NPL 2000-0371

DOCKETS 50-266 AND 50-301
SUPPLEMENT 5 TO APPLICATION FOR AMENDMENT TO
FACILITY OPERATING LICENSE APPENDIX A:
TECHNICAL SPECIFICATIONS IMPROVEMENT PROJECT
RESPONSE TO RAI ON ITS SECTIONS 3.4 and 3.9
POINT BEACH NUCLEAR PLANT, UNITS 1 AND 2

Attachment 1 – NMC RAI Response to ITS Sections 3.4 and 3.9

3.4.1 RCS Pressure, Temperature, and Flow Departure from Nucleate Boiling (DNB) Limits

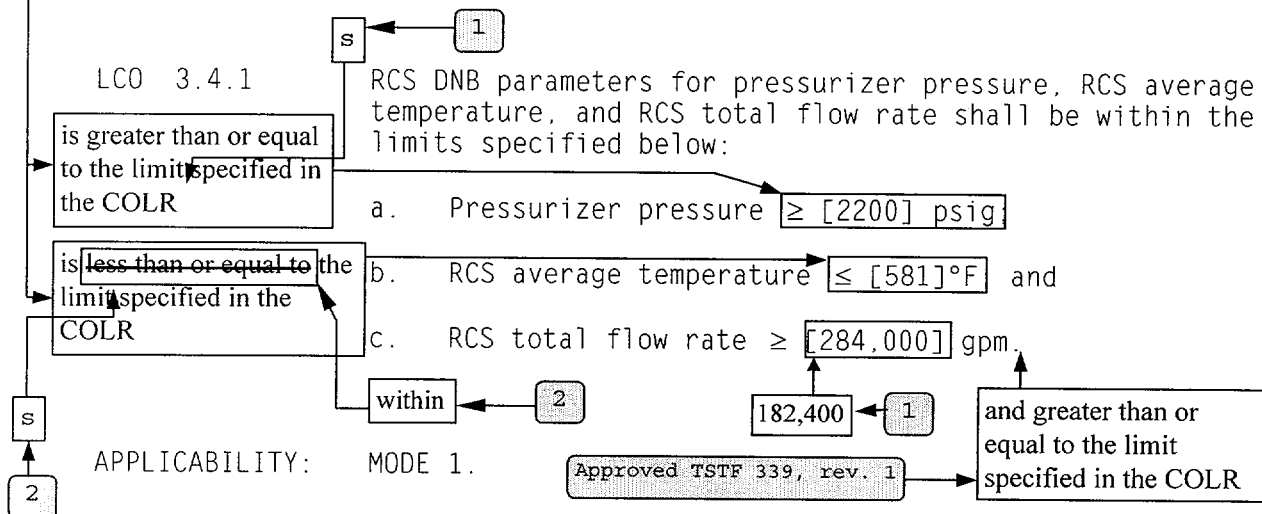
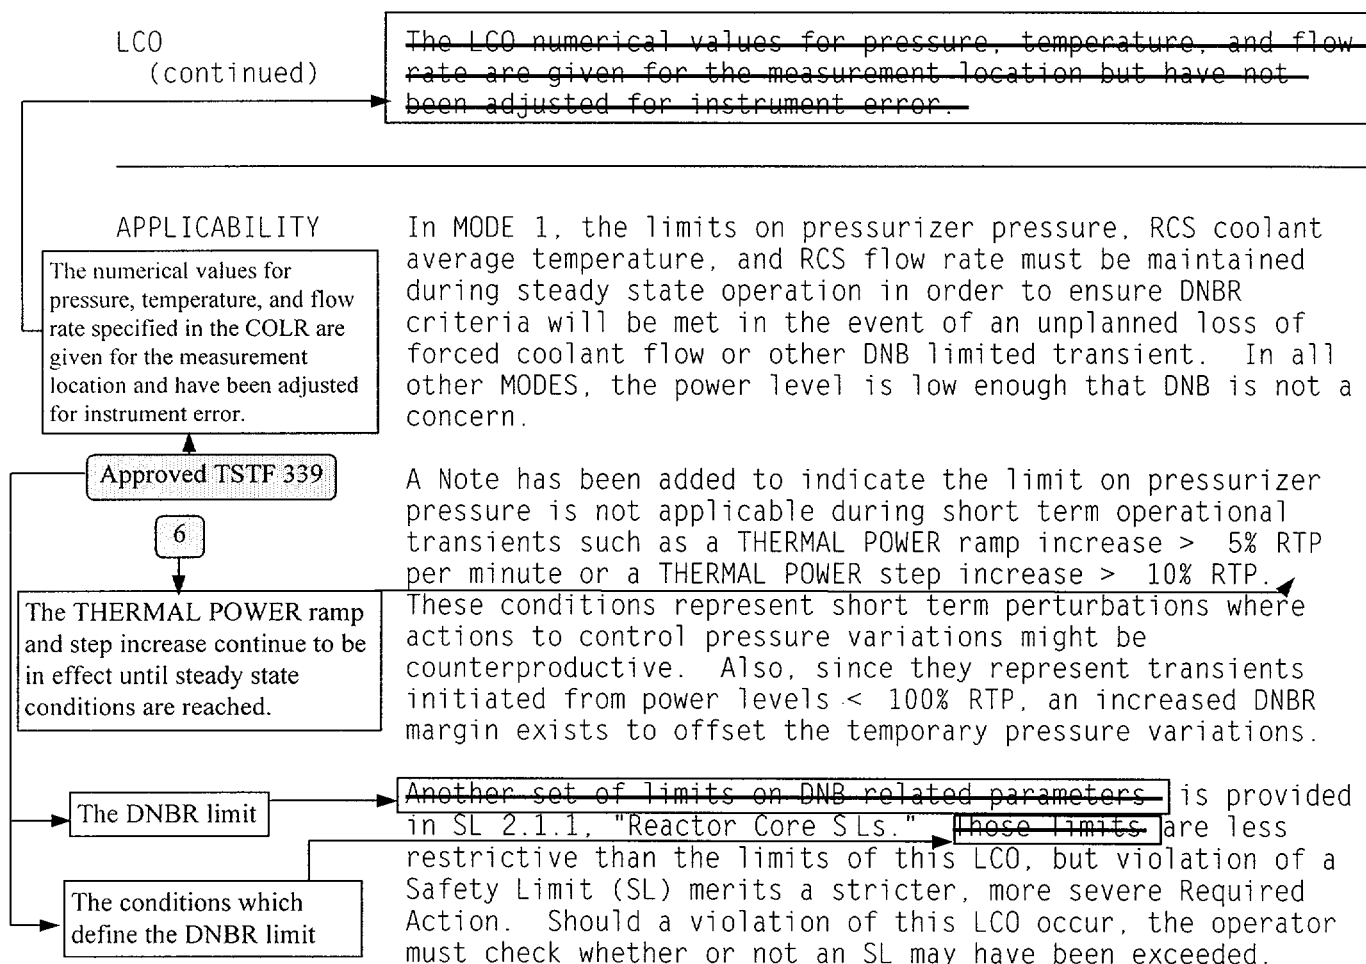
Comment: There is not a discussion in the Bases concerning when either of these limits apply, and whether the limits change linearly between these pressures. Provide an explanation.

Proposed ITS section 3.4.1 has been completely revised based on incorporation of the Core Operating Limits Report (COLR), TSTF-339, and Amendments 193/198, approved 2/08/00 (related to incorporation of new fuel design at PBNP). The pressurizer pressure limits and their explanation are now included in the COLR, and are dependent on the type of fuel design used in the reactors (i.e. the upper limit is to be used when there is 422V+ fuel in the reactor). The COLR was submitted to the NRC as TSCR 218, dated 03/02/2000.

As a result of incorporating these submittals, DOC M.02 was changed to "not used" and new DOC LA.01 was created (since this change is now less restrictive), a new "LA" NSHC was created, JFD 01 and JFD 02 were slightly revised, the CTS markup, the NUREG markup, and the proposed ITS and associated Bases were revised as appropriate (see attached markups).

RAI 3.4.7-3

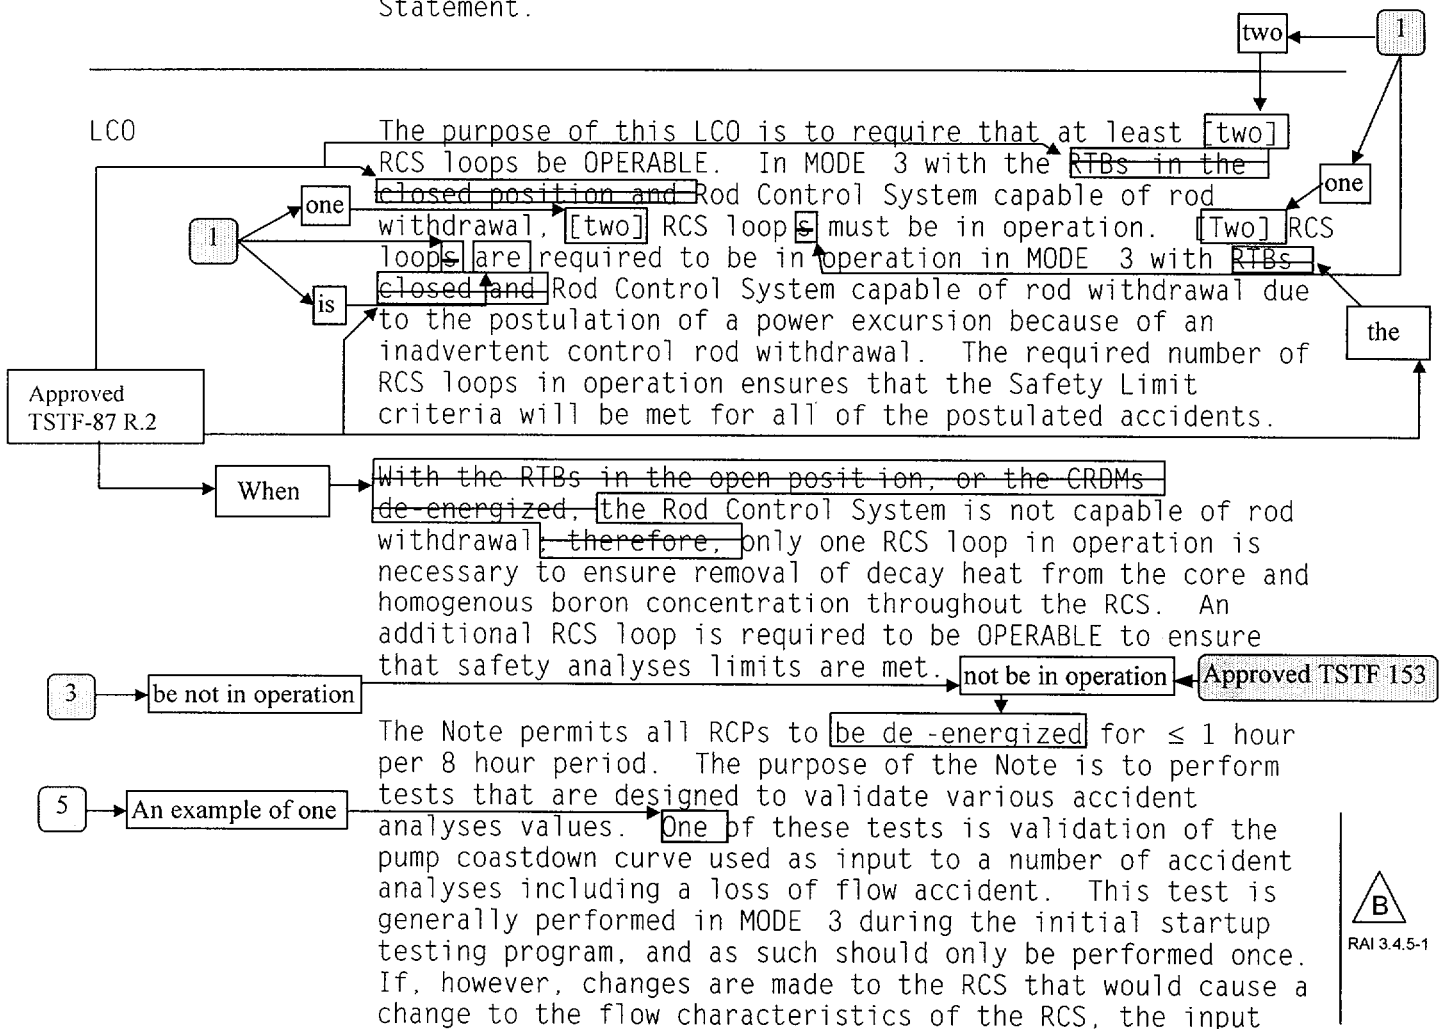
Comment: Recommend also adding “narrow range” to ITS SR 3.4.5.2 and ITS SR 3.4.6.2. Request you submit a TSTF change proposal to modify the STS.

ITS SR 3.4.5.2 and ITS SR 3.4.6.2 have been modified to specify that steam generator level must be $\geq 30\%$ narrow range. Appropriate justifications for these changes have also been provided.

3.4.12 Low Temperature Overpressure Protection (LTOP) System

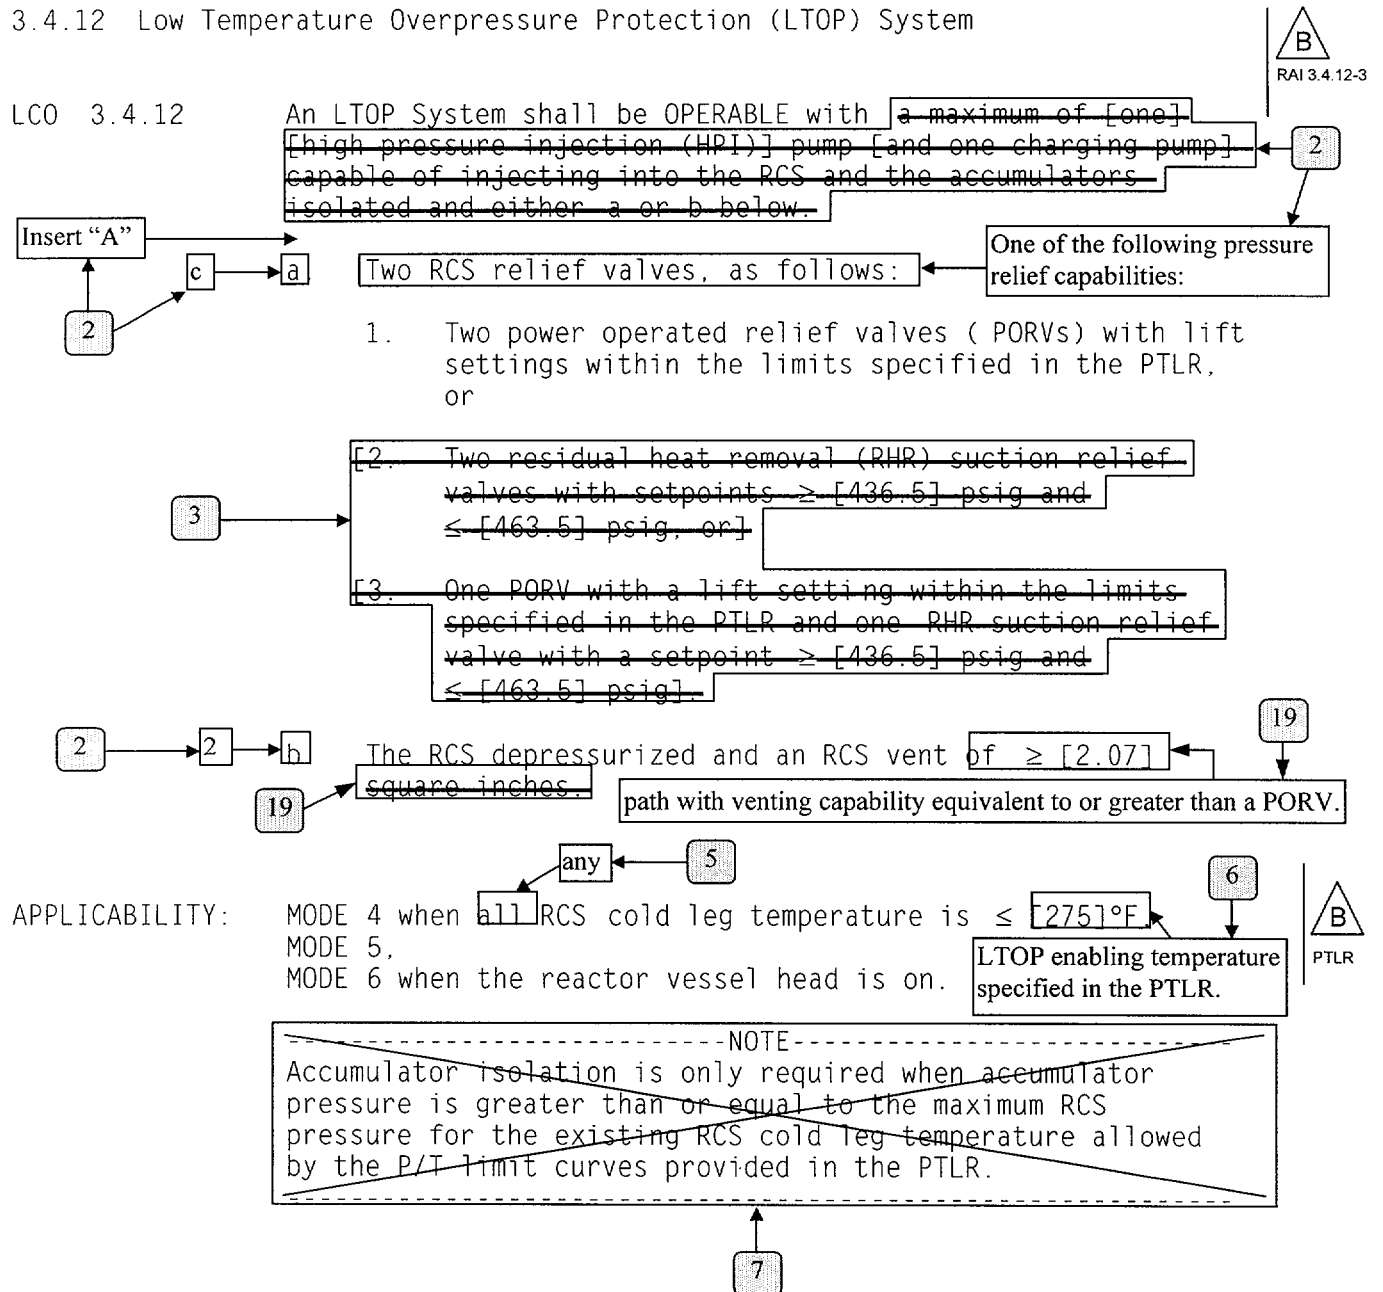
Comment: The CTS refers to the LTOP System, as does the STS. The ITS refers to LTOP Trains of equipment. When LTOP is controlling pressure it is appropriate to refer to the equipment configurations and functioning as the LTOP System; it seems awkward not to refer to it as the LTOP System.

ITS 3.4.12 LCO statements have been restored to the designations presented in the ISTS, in order to refer to the LTOP "configuration" as a system. This change also results in the deletion of JFD 1.

Sections 3.4.10 and 3.4.12 have been completely revised based on changes to the LTOP enabling temperature, which was submitted as part of TSCR 219 on March 14, 2000 (Adoption of PTLR).
